Upper Silver Creek Restoration Project Year 4 Monitoring Report

NCDMS Project ID Number – 94645

**Burke County, North Carolina
NCDMS Project ID Number – 94645**

Subject: Response to DMS comments on the Year 4 Monitoring Report Review for the Upper Silver Creek Stream and Wetland Restoration Project; Catawba River Basin - CU# 03050101; Burke County, North Carolina; NCEEP Project # 94645; Contract No. 003270

Figure 6. Cross-sections with Annual Overlays

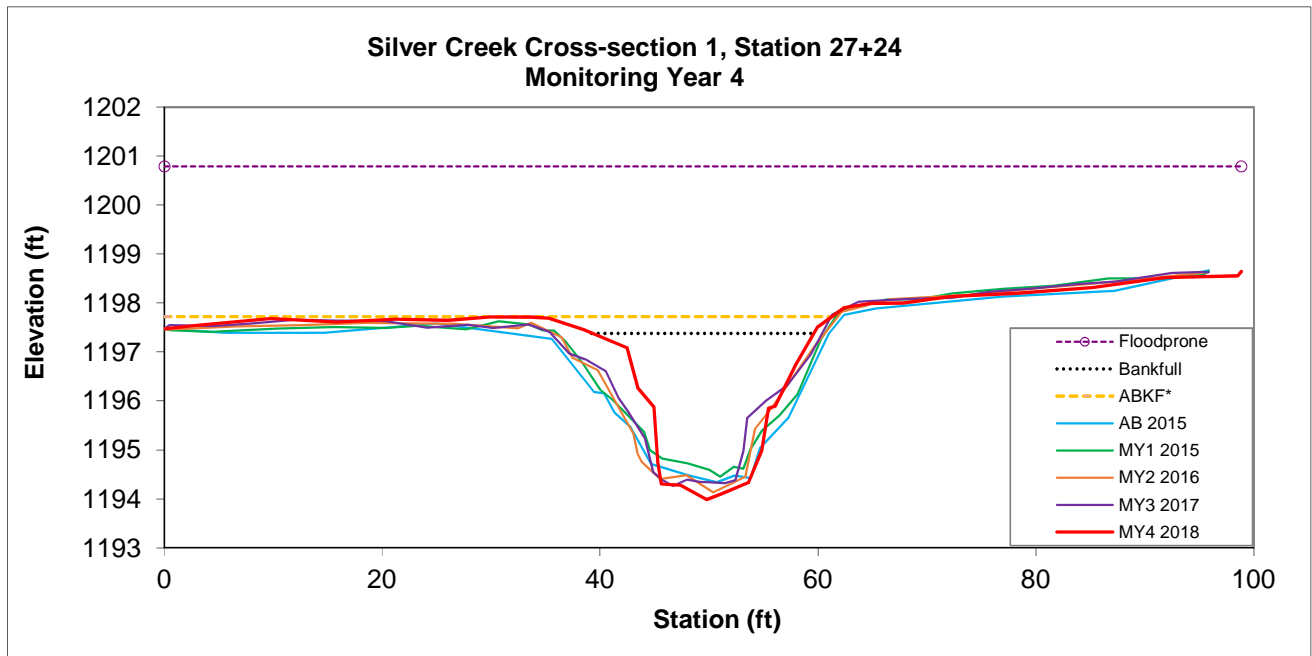
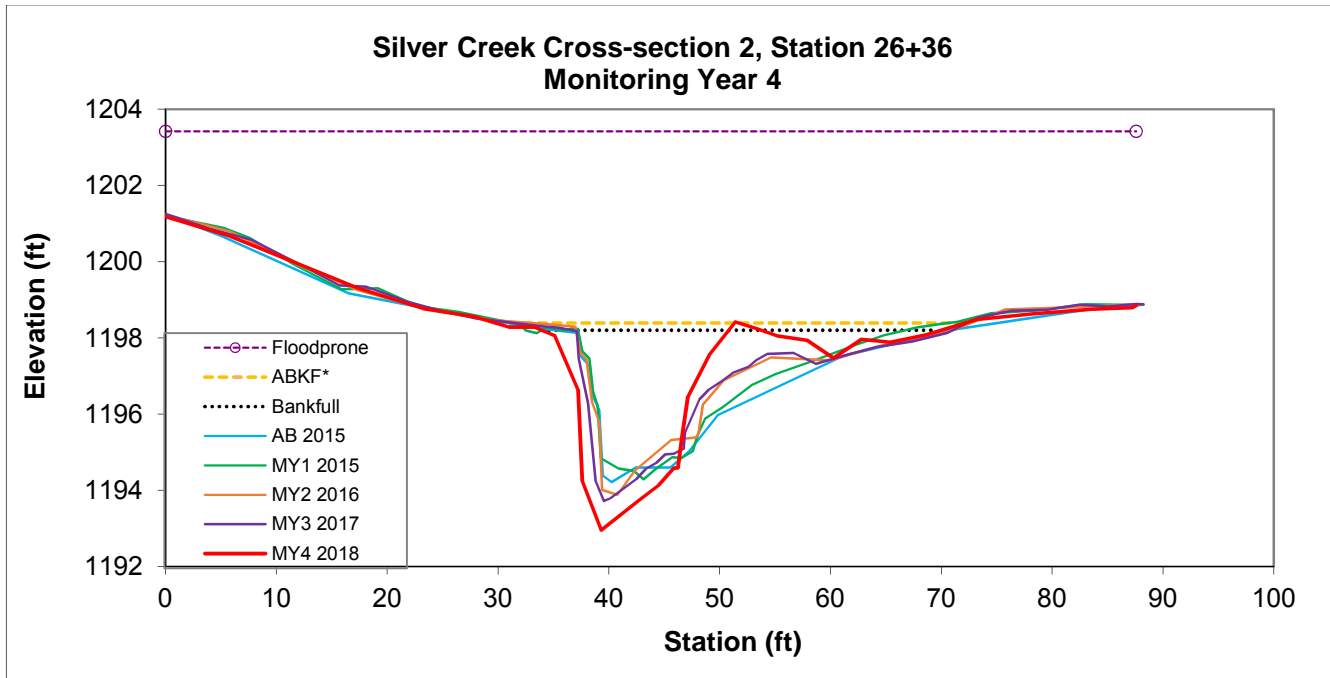
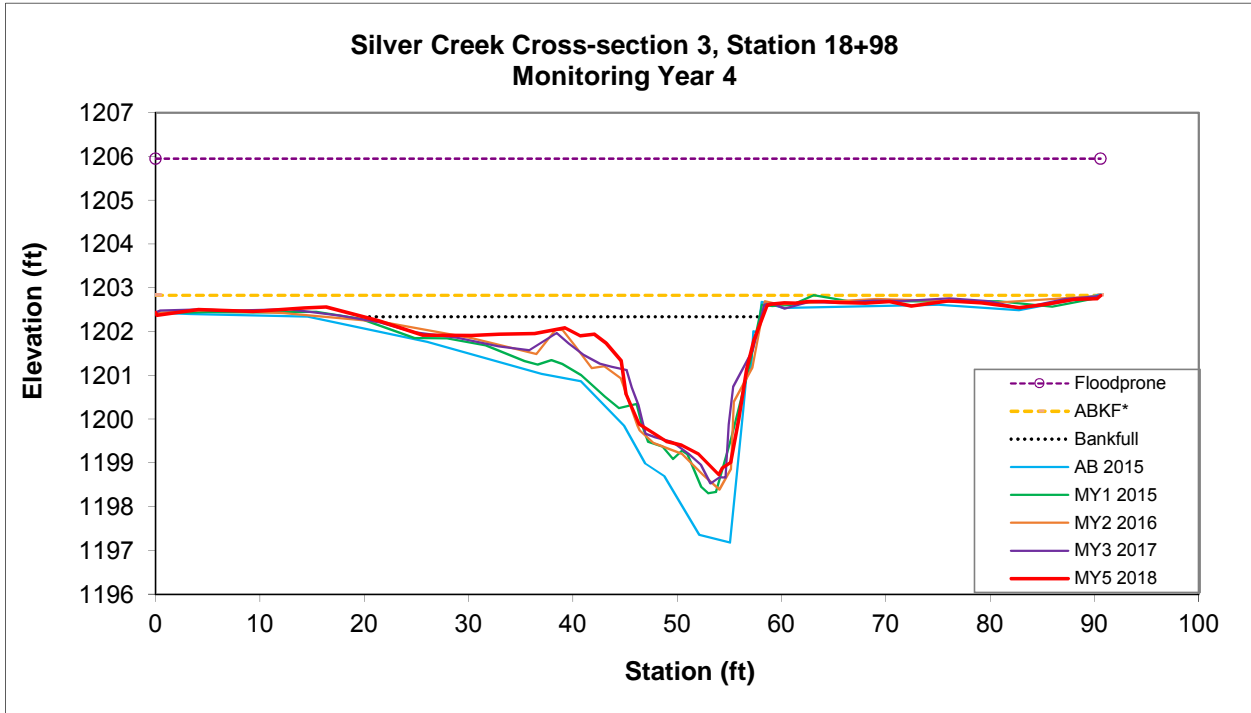
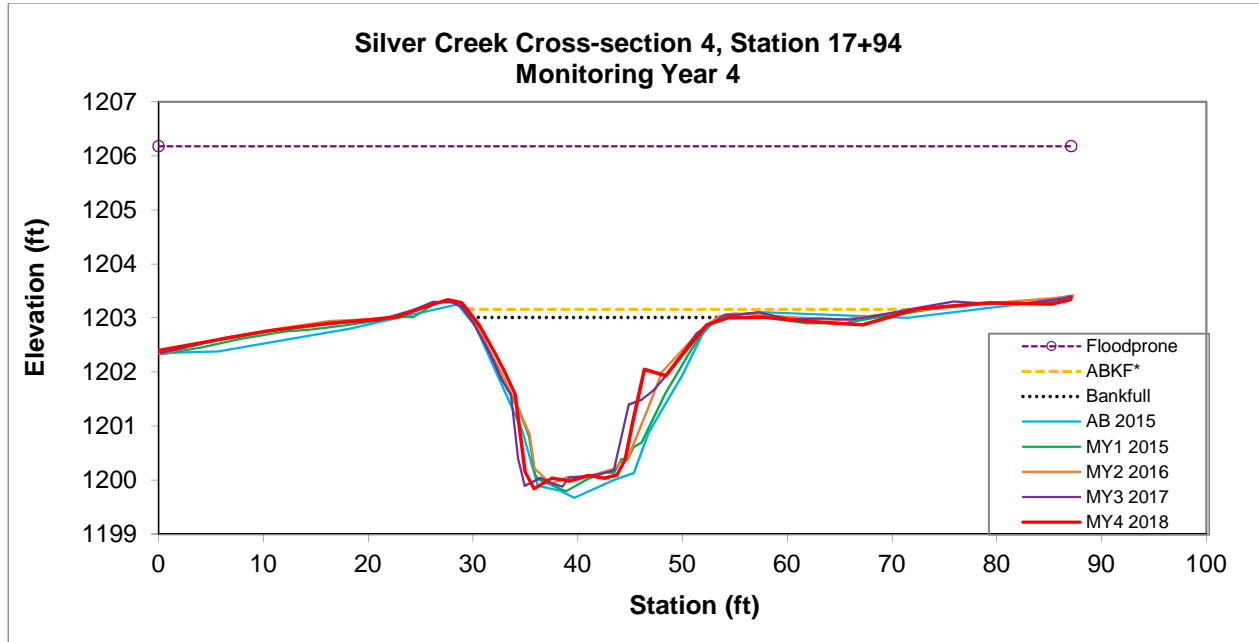
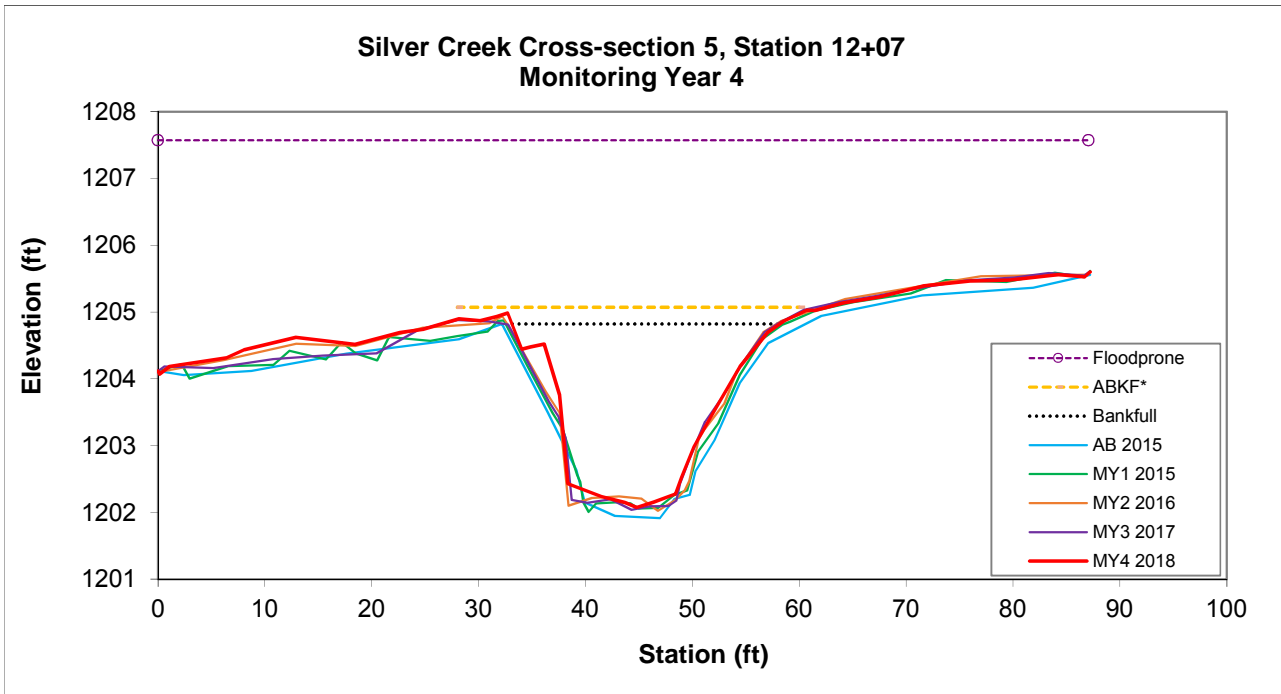
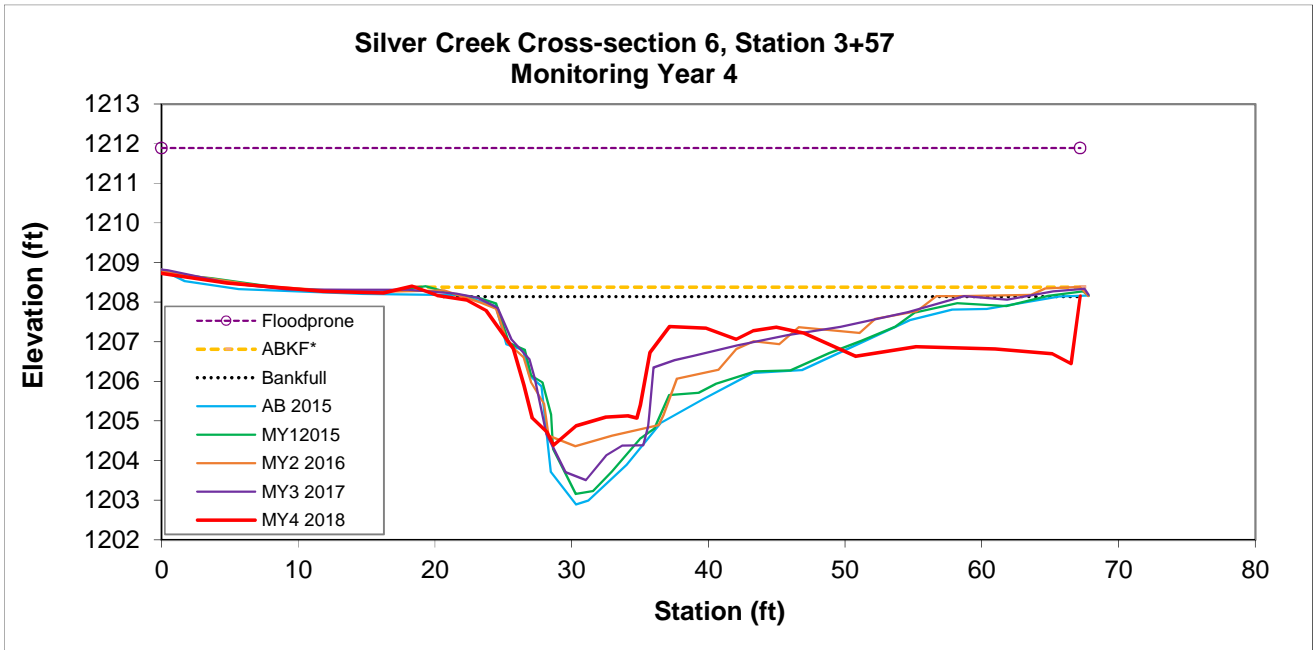
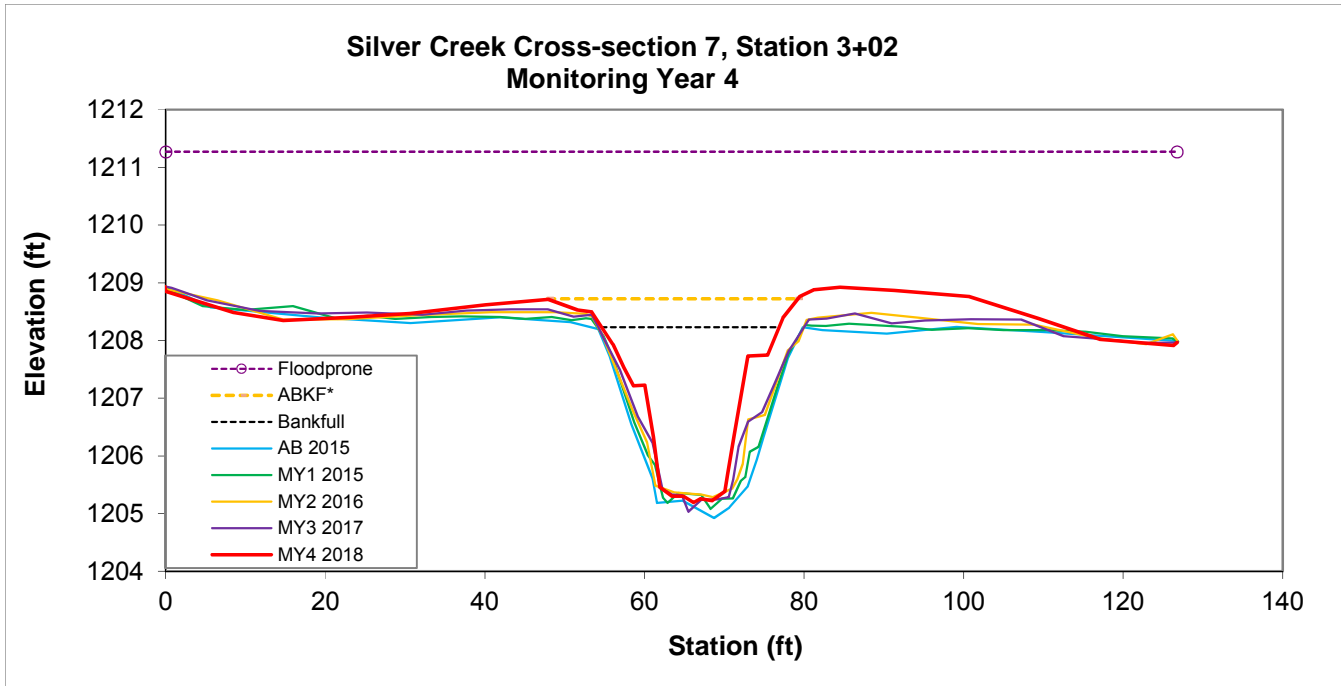
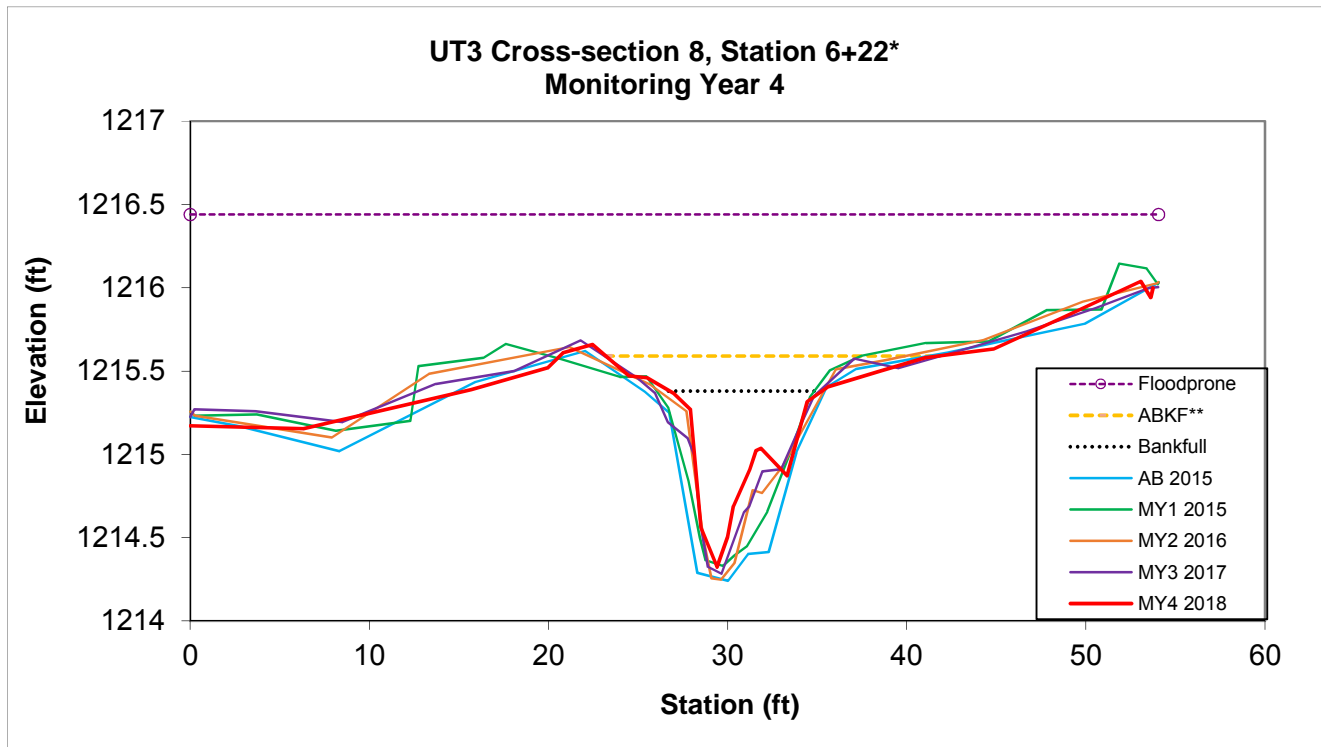
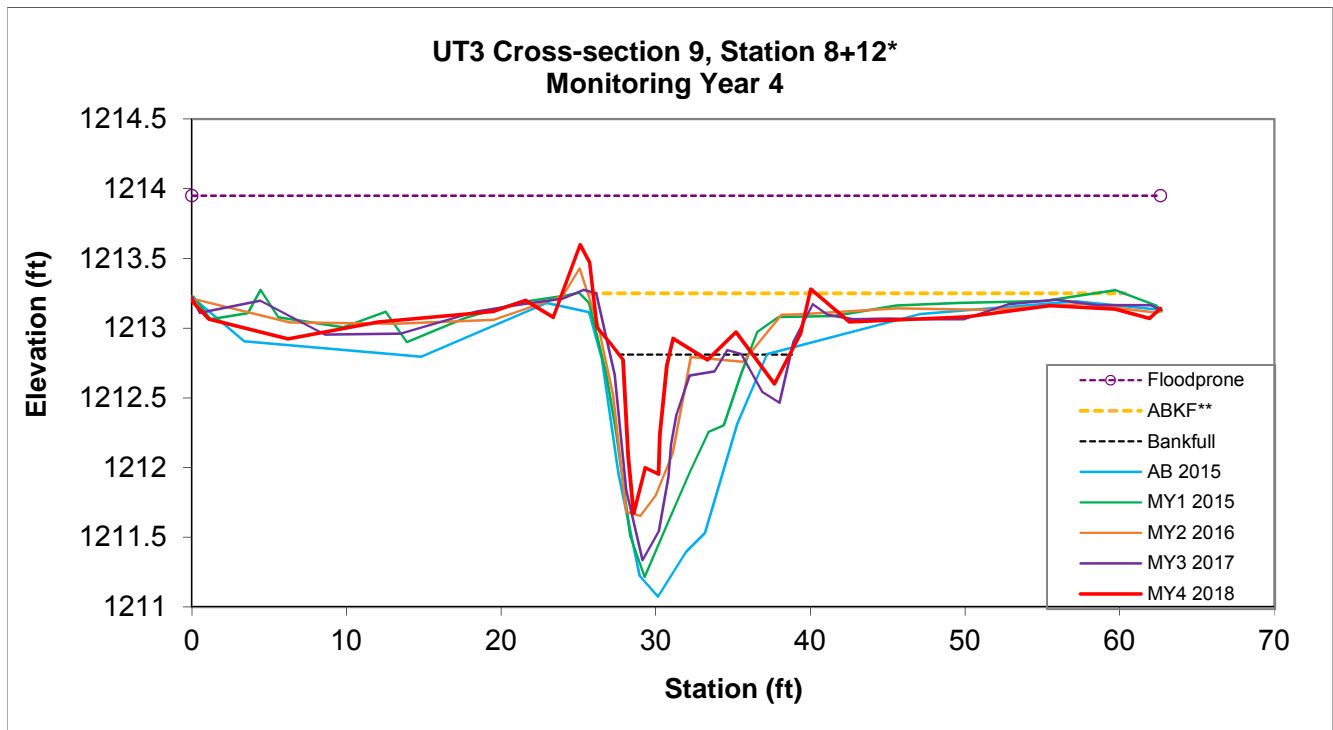
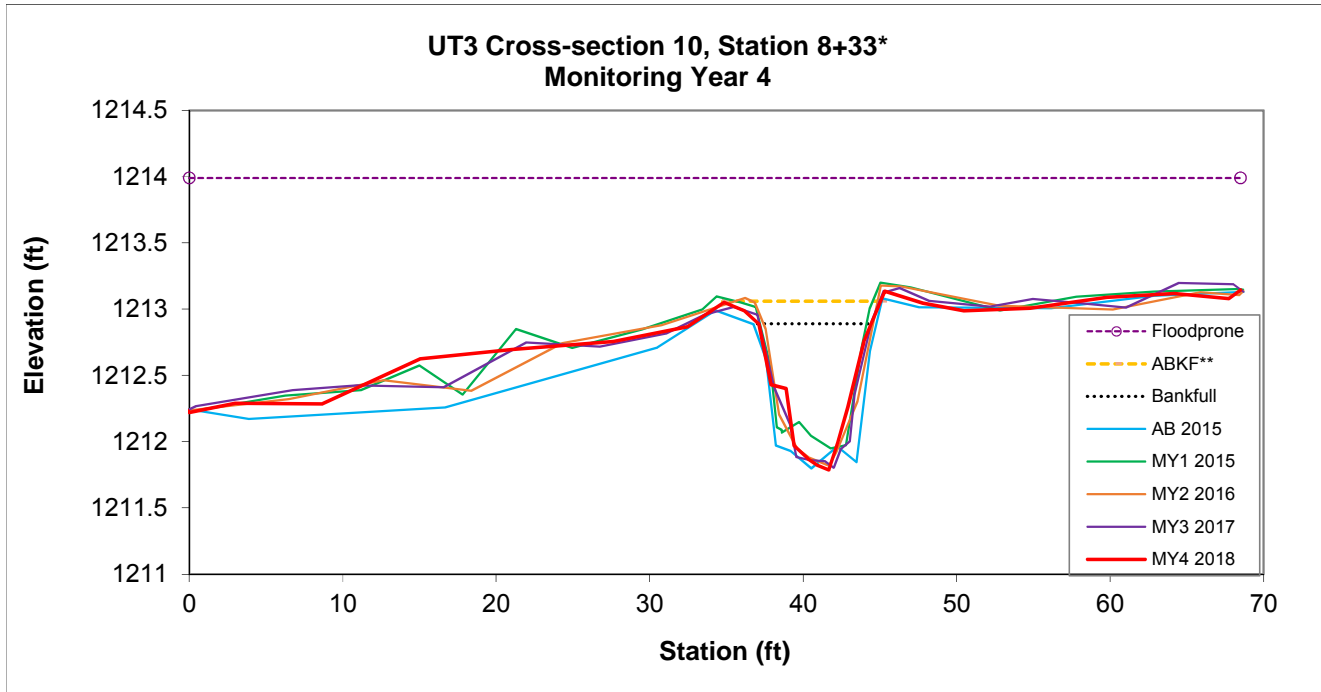
- Please confirm that the MY4 (2018) BHRs have been calculated based on the attached DMS technical guidance. The A_{bkf} reported in Table 11 does not show the same area being used as the asbuilt data. Please add note on table indicating that beginning in MY4, the bankfull elevation and channel cross section dimensions are calculated using a fixed A_{bkf} as described in the Standard Measurement of the BHR Monitoring Parameter provided by NCIRT and NCDMS (9/2018). Please update table and cross-section graphs as necessary with revised measurements.

The BHRs have been calculated based on our best understanding of the new methodology and additional input from the Raleigh NCDMS staff (Greg Melia and Jeff Schaffer). The A_{bkf} that is reported in Table 11 is the A_{bkf} for MY4 based on the MY0 bankfull elevation used in each report. The BH Ratio reported on each cross-section and in Table 11 is based on the A_{bkf} reported in the MY0 report and requested in the new guidance. This involves adjusting an elevation transect line until the MY0 cross-sectional area is indicated under that line (call this elevation ABKF). The BH Ratio is the ratio of the depth from the low bank of that monitoring year (call this TOB elevation) to that years thalweg and the depth from the ABKF to that years thalweg, BH ratio = $(TOB-TW)/(ABKF/TW)$, where TOB and TW are for the monitoring year

and ABKF is based on the MY0 A_{bkf}. All cross-sections and data shown in the tables are based on this methodology and updates have been made as requested.
